# SERVICE BULLETIN

M-967

Safety Recall Code 063

June 30, 1988

Figure 1. Springer Front Brake Caliper

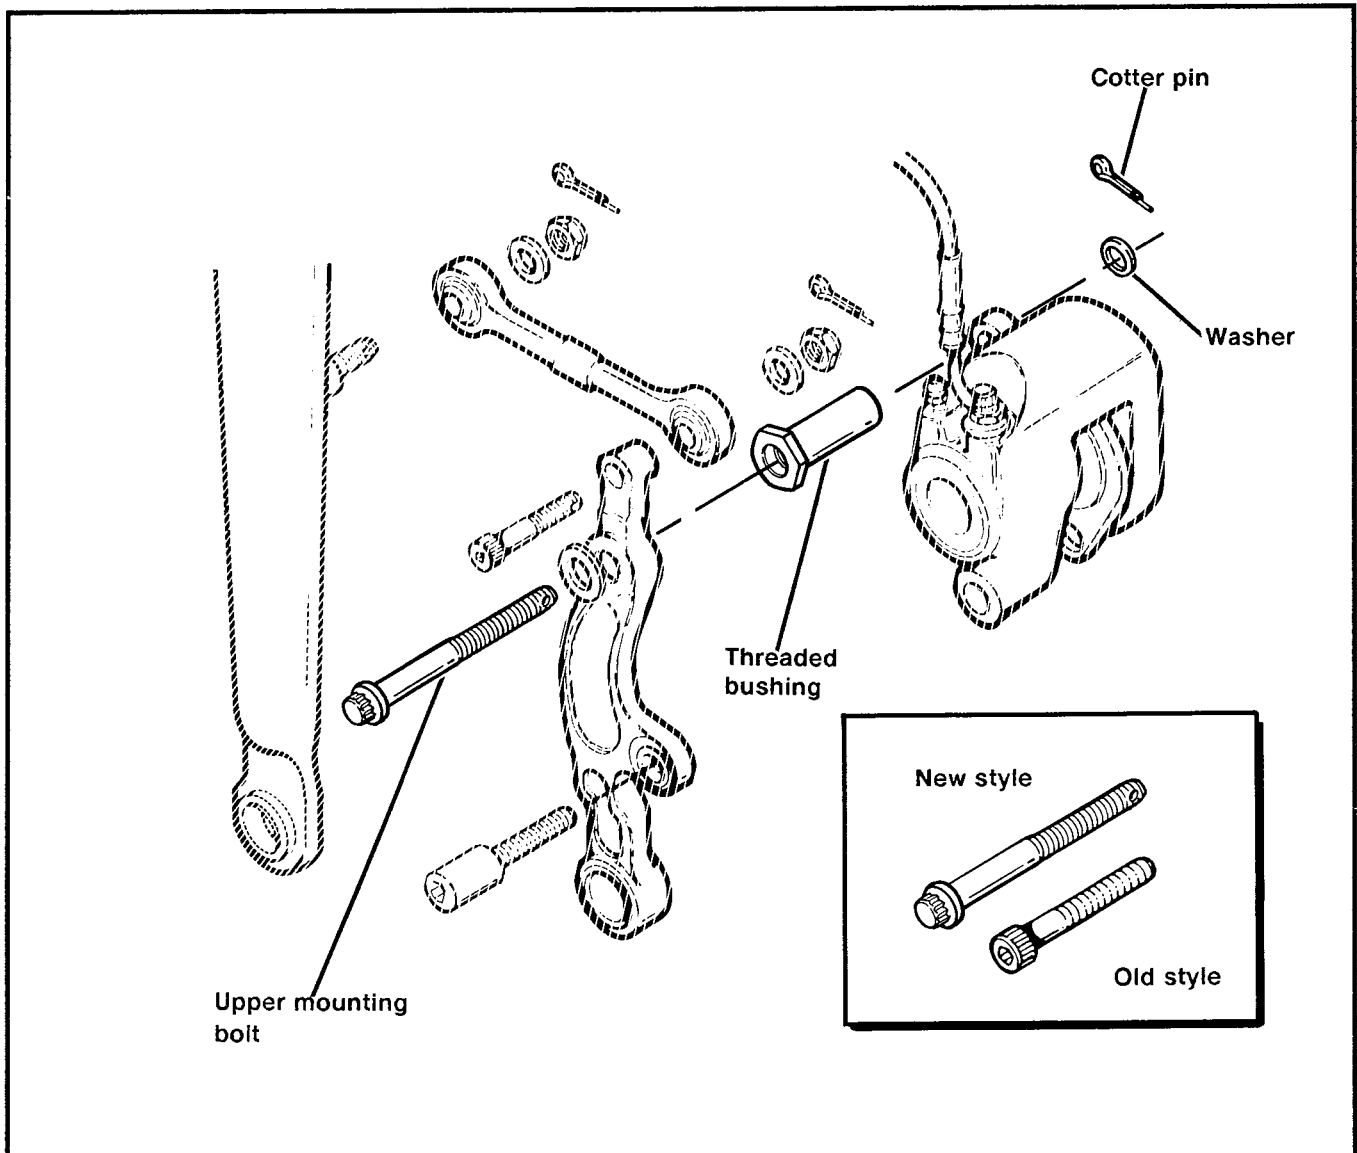
The upper front caliper mounting bolt head is being changed to a 12 point style, drilled at the thread end to accept a cotter pin. Because the assembly process requires the upper and lower bolts to be torqued differently, this change to the upper bolt will make it easier to differentiate one bolt from the other. See Figure 1. Additionally, a washer and cotter pin are being added to this bolt to further restrain movement, in the unlikely event all bolt torque was lost.

**To further determine if a particular FXSTS vehicle is involved in the 063 recall, inspect the caliper upper mounting bolt. Figure 1 illustrates the old and new style bolt.**

1. Press caliper against the brake disc to relieve pressure on the disc from the brake pads.
2. See Figure 1. Remove upper mounting socket head bolt and washer. Retain washer.
3. Remove lower mounting pin.
4. Slide caliper forward, off the brake disc and mounting plate, for access to the threaded bushing.

1. Install new threaded bushing.
2. Slide caliper with mounting plate back into proper position.
3. Install new upper mounting 12 point bolt in new threaded bushing with original washer.
4. Install lower mounting pin. Tighten pin to 25-30 ft-lbs torque.
5. Tighten upper mounting bolt to 42-46 ft-lbs torque. Place a screwdriver between a flat on the bushing and the caliper body to hold the threaded bushing in place.
6. Install supplied washer and cotter pin.
- Make a note of this Service Bulletin in the Service Manual Supplement - FXSTS Front Fork Assembly.
7. Squeeze the brake lever two or three times to restore brake pad pressure.
